Fort Donelson National Battlefield

Accessibility Assessment

FINAL REPORT

Findings and Recommendations

Corrective Action: Add audio-visual system

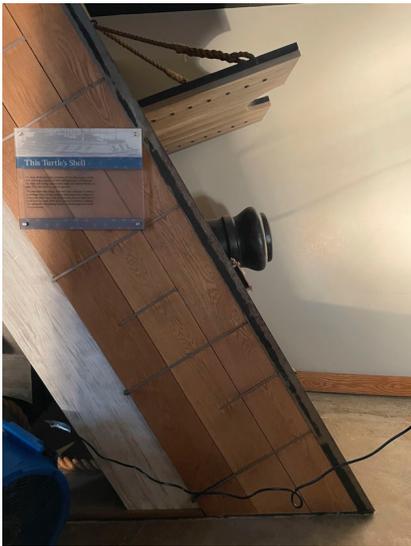
The park information video is not presented with an accessible audio-visual system.

Work with the Harper's Ferry Center to ensure that new audio-visual equipment is accessible and compliant with NPS regulations, as well as federal law. All videos must have audio description and must be shown in open captions. It is the responsibility of the park to acquire appropriate equipment to deliver this.

Corrective Action: Add tactile model for the gunboat

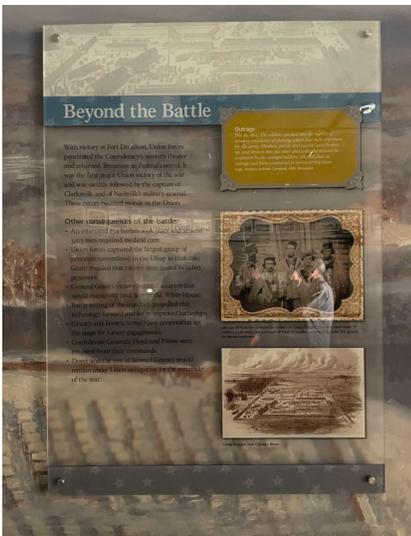
The gunboat model does not allow people with disabilities to experience this crucial story to the park. The gunboat is not within required reach ranges, and the slope of the interactive makes it difficult to engage with the exhibit.

Add a tactile model of the gunboat.

Corrective Action: Add tactile models and maps

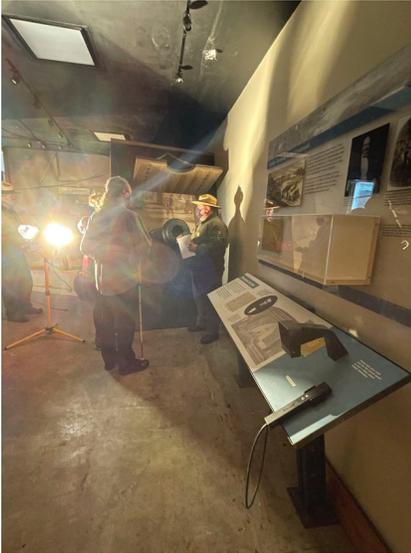
Current space has few tactile models and maps to represent important parts of park engagement.

Acquire more tactile elements for museum engagement. This may include but is not limited to the following: models of major buildings on the grounds and major locations; representations of objects where interaction may not otherwise be possible; models of historically significant features, such as canons, the gunboat, the earthworks, and uniforms; and maps to provide orientation and show the locations of the rivers, forts, and the larger campaign. Potential tactile elements should also represent things that may not have been directly involved in the battle itself but were still important for the context, such as period locomotives.

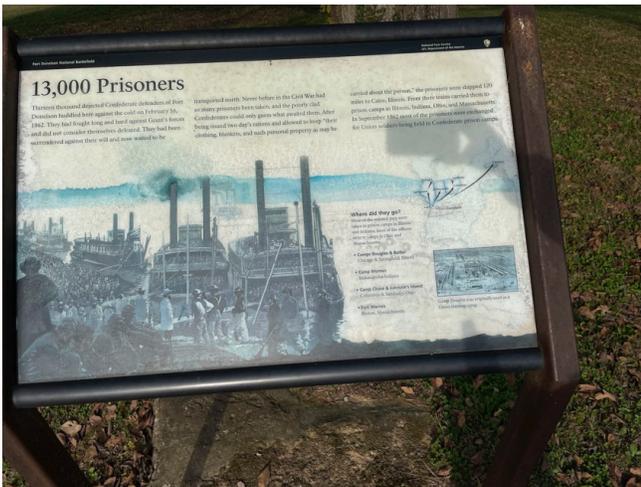
Maintenance deficiencies on the grounds, such as grass overgrowth and grout loss, have created accessibility barriers.

Develop standard operating procedures for continual route maintenance. Procedures should include regular grout maintenance and path clearances. Other barriers (such as trash cans placement in accessible locations) can be addressed through these procedures.

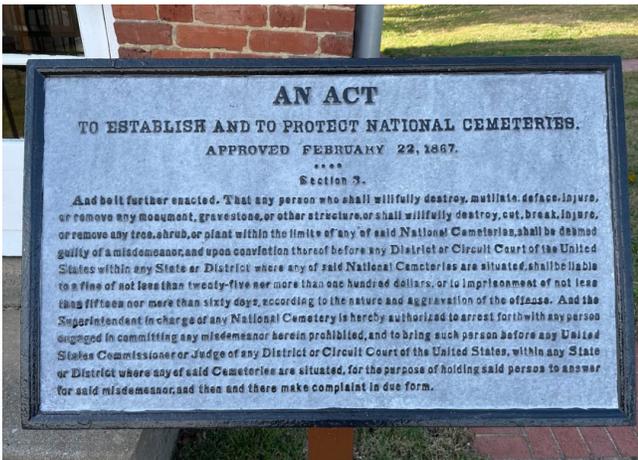
Park waysides do not currently have audio description.

Develop audio description for waysides. This could be achieved either by developing internal capacity to create audio descriptions or hiring contractors. Investigate developing new waysides where needed.

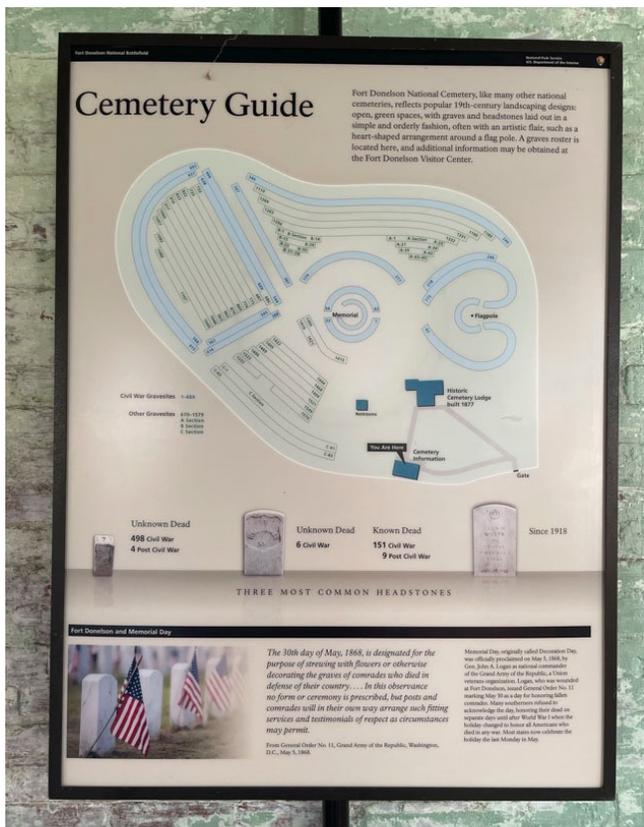
The brochure holder on top of the "Find A Grave" kiosk is out of reach range.

Lower the brochure holder to a location within proper reach range as defined in ABAAS 308.2 (48 inches with up to 20-inch obstruction, 44 inches for anything greater).

Corrective Action: Replace drain cover grate with compliant grate

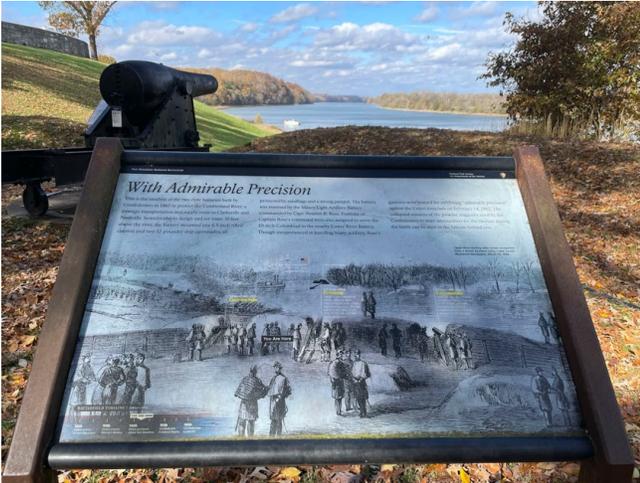
A grate with 3" wide openings covers a drainage pipe.

Replace this grate with a compliant and safe solution or investigate potential mitigating options if this is impossible. NPS may consider having a custom-made grate to meet ABAAS requirements while having an appearance appropriate to the historic timeframe.
